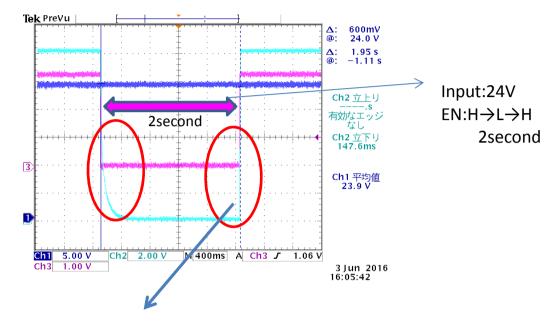
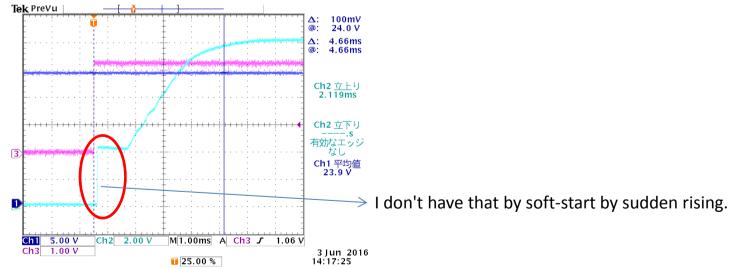
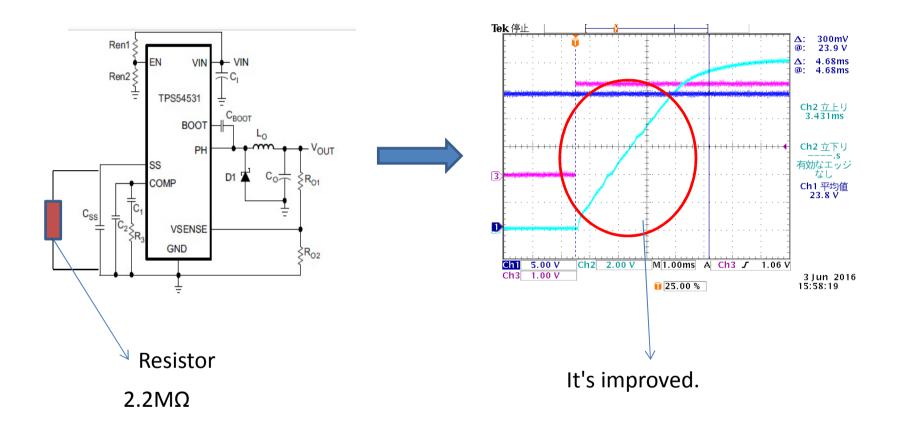
Ch2 : output Voltage 12V(VCC-TCON)

Ch3: NE pin

May not a capacitor of SS be discharged?
